**City of Poughkeepsie
Historic District and Landmarks Preservation Commission
Meeting Agenda**

**RE: Pelton Mount Carmel
36 North Clover Street
Revised Submission**

Re: Project: Pelton Mount Carmel
36 North Clover Street
Re: Revised design of proposed development for HDLPC Approval

PZ-12

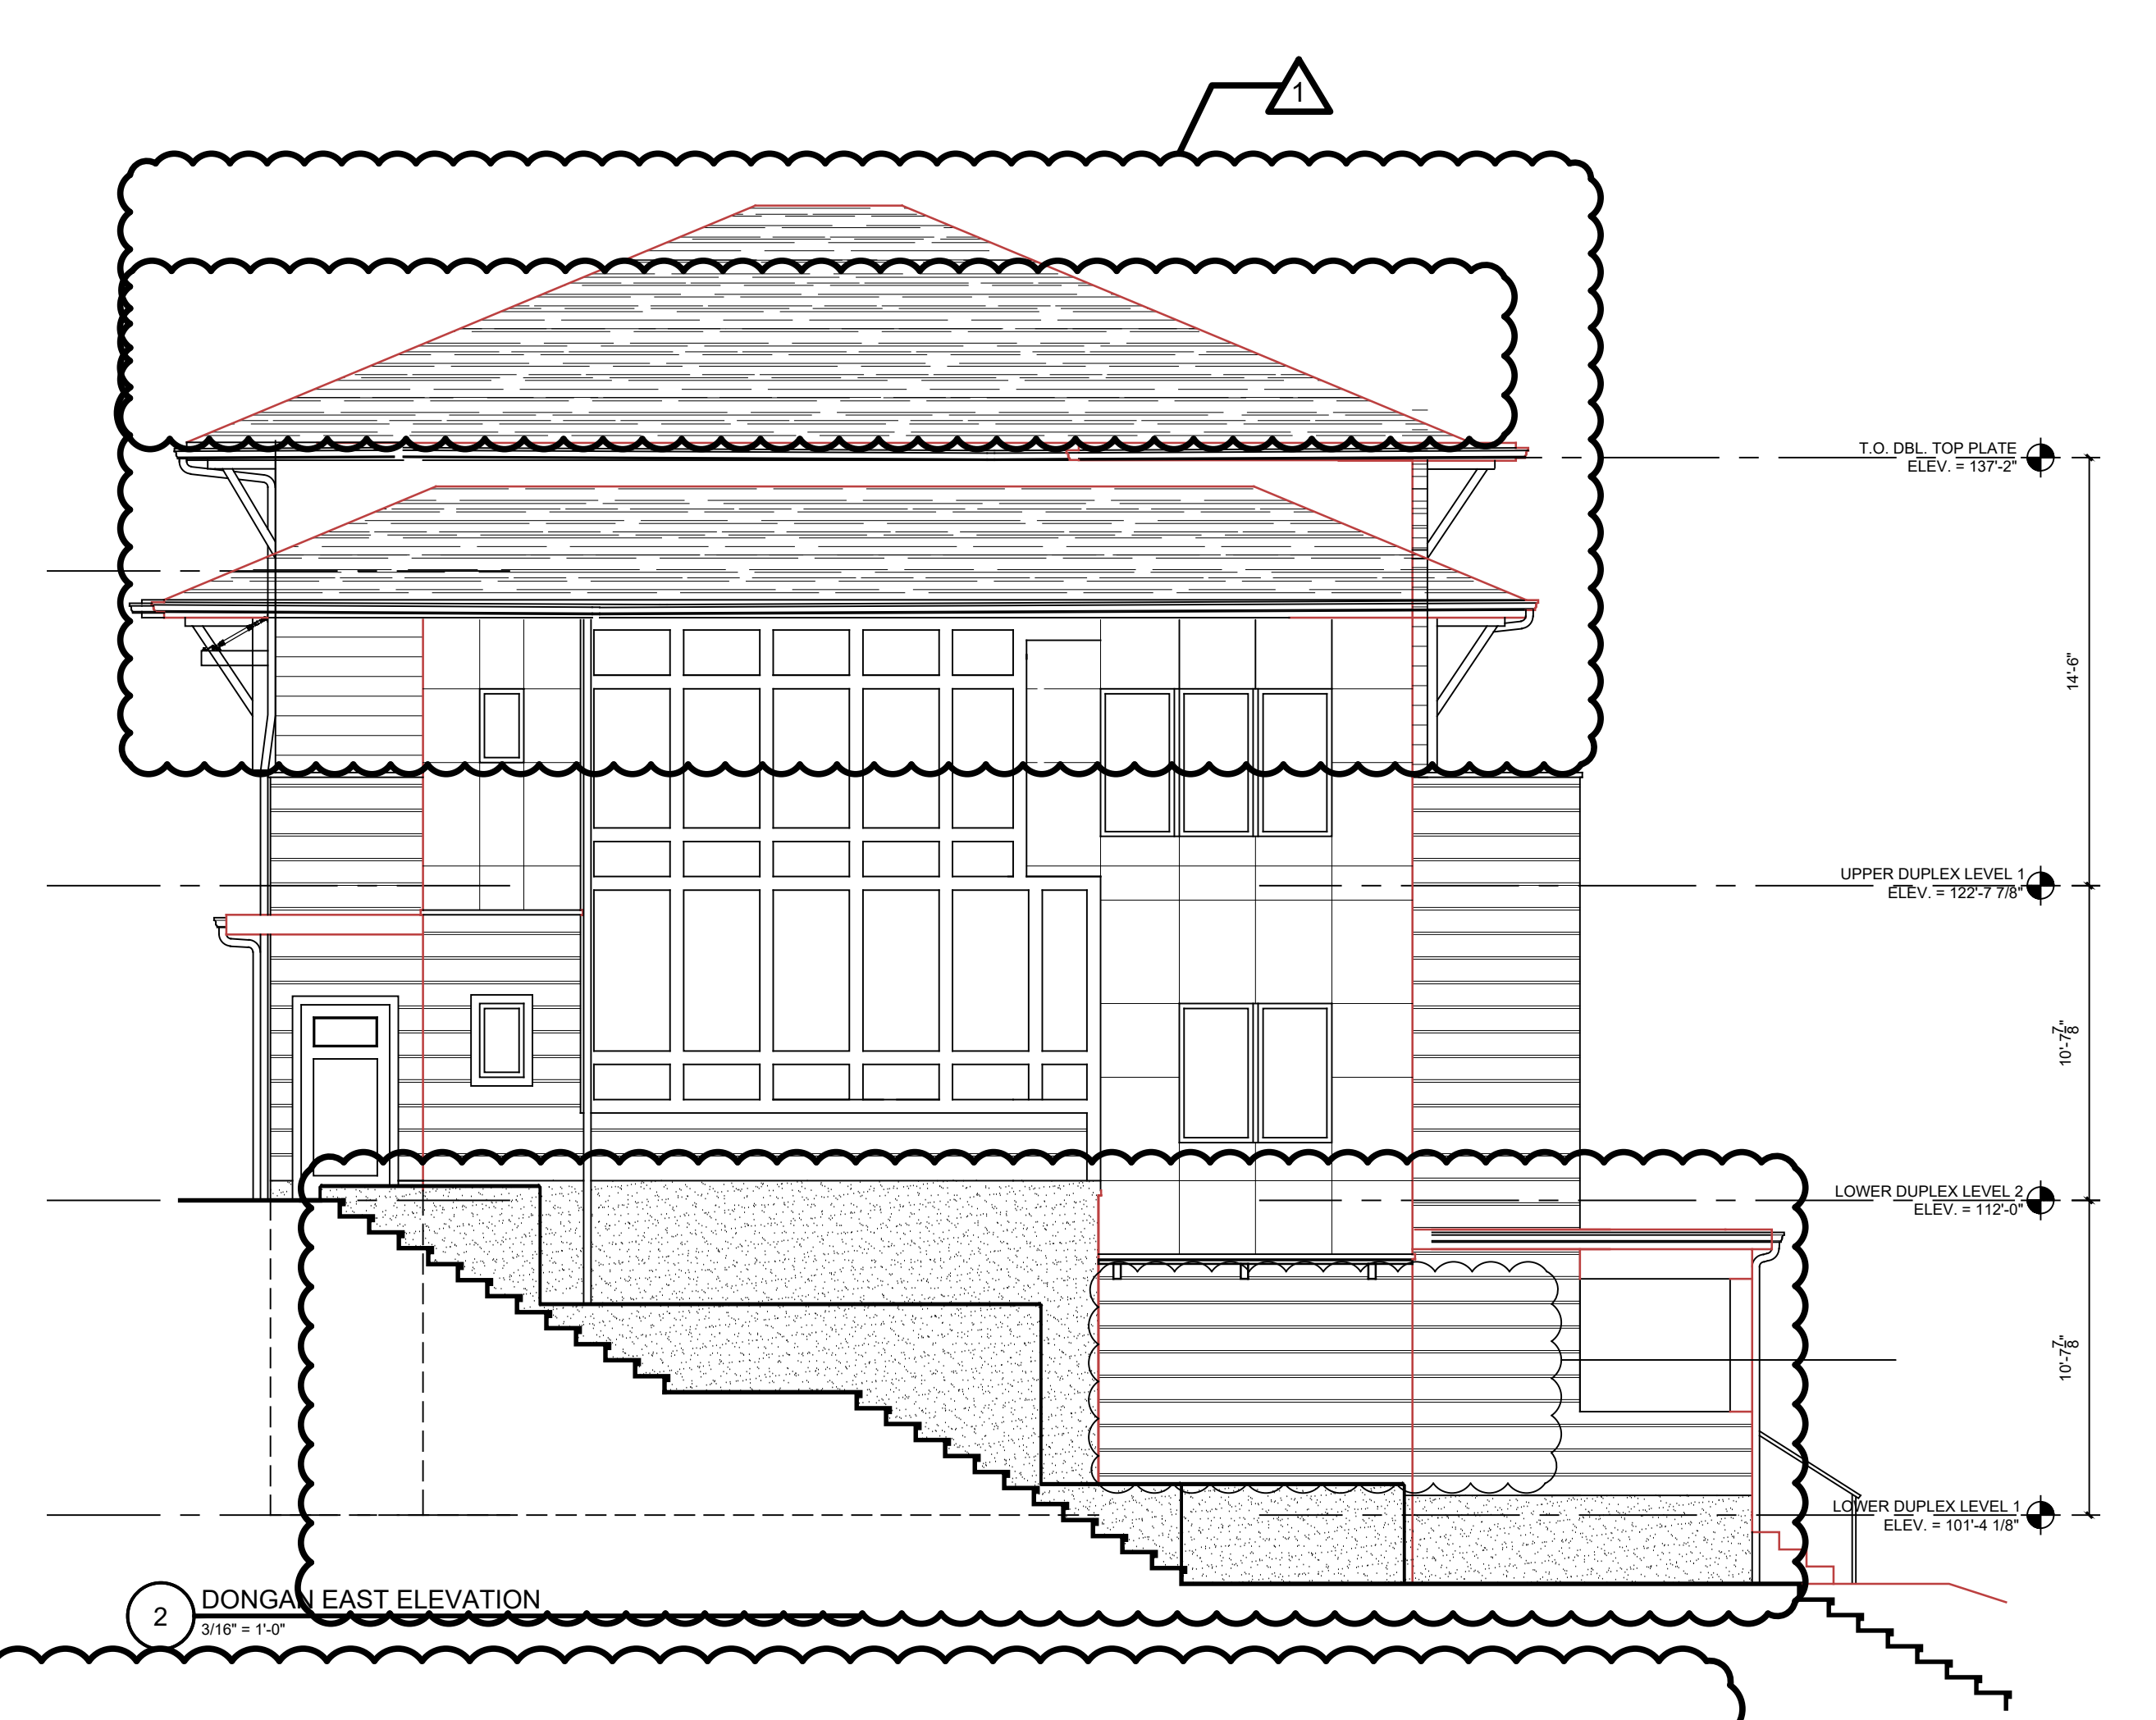
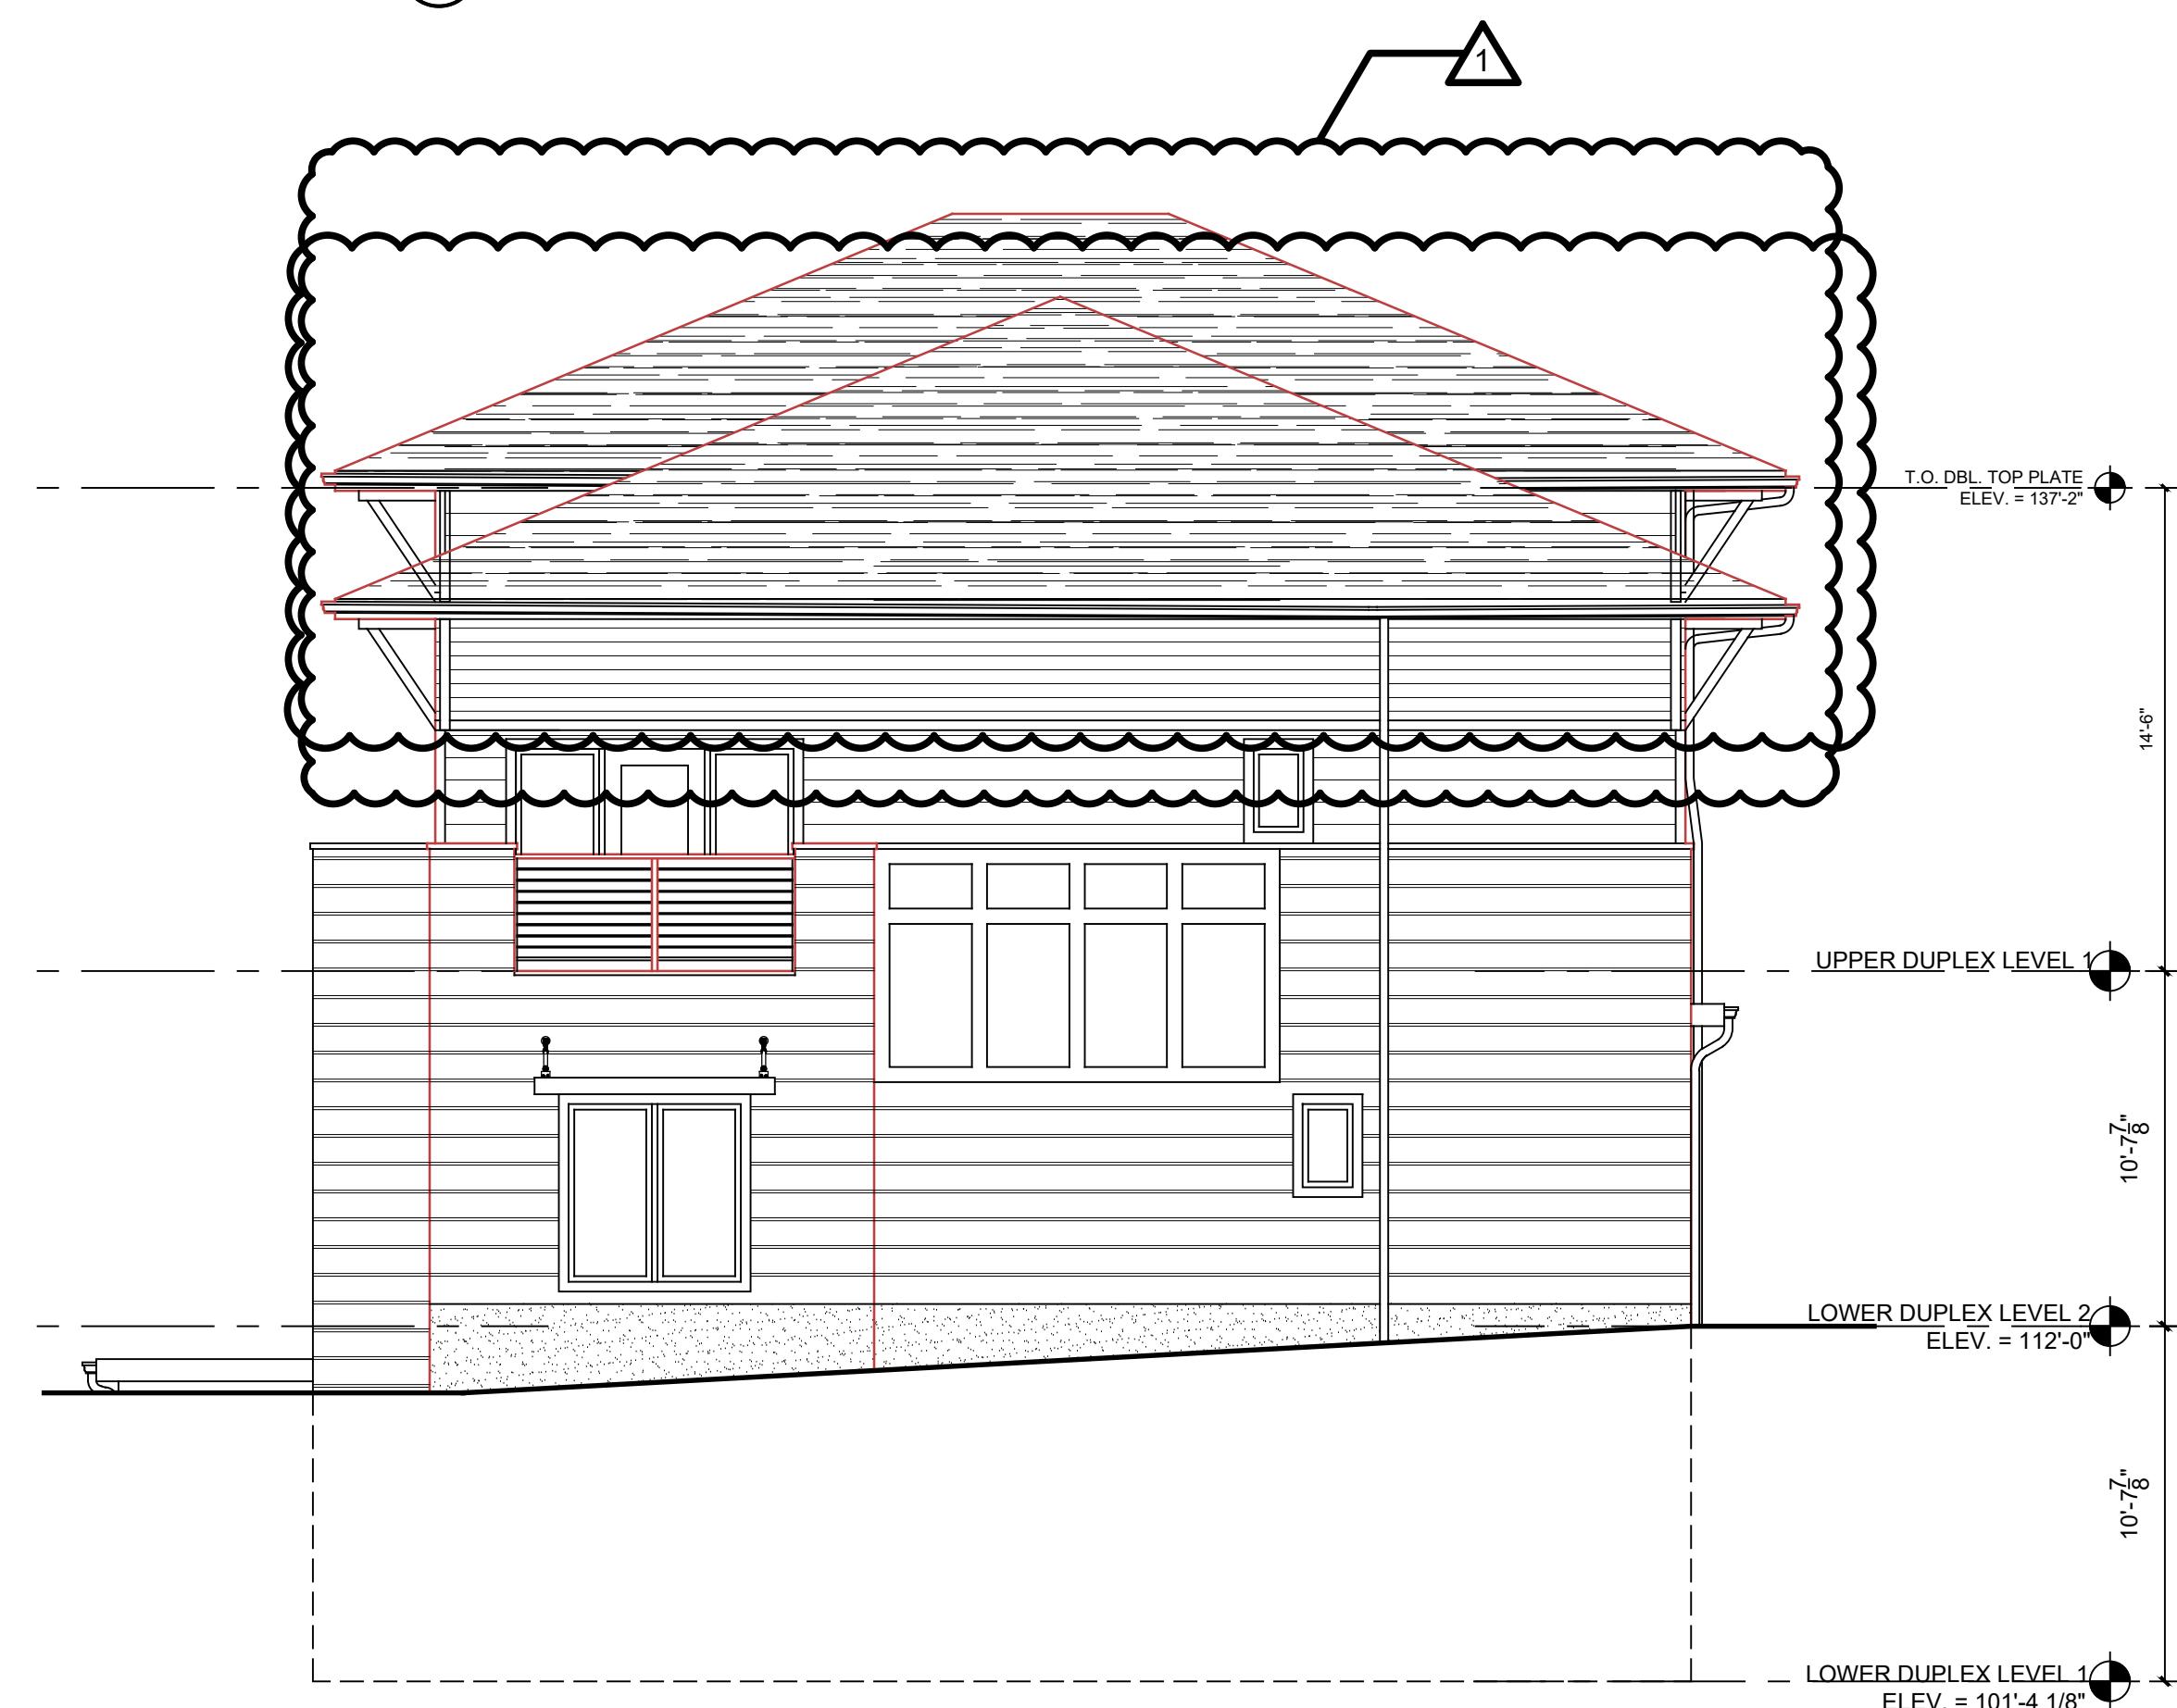
Sheet PZ-12 – Preliminary Elevations - Dongan:

1. On all elevations, the Upper Duplex Level 2 has been removed, thus lowering the height of the building.
2. The ridgeline of the roof has been lowered to a ridge height of 33'-9 3/8"
3. A "Tower" element has been created on the north and the south elevations of the building, reducing the width of this form. Refer to Elevations 1 & 4.
4. Elevation 2 – Dongan East Elevations
 - b. The Lower Duplex Level 1 has been modified to accommodate the proposed commercial space. This includes changes the elimination of a window for the former residential unit.
5. Elevation 4 – Dongan North Elevation
 - a. The Lower Duplex Level 1 has been modified to accommodate the proposed commercial space. This includes changes in the building materials and the window configuration in this area and the elimination of a door to the former residential unit.
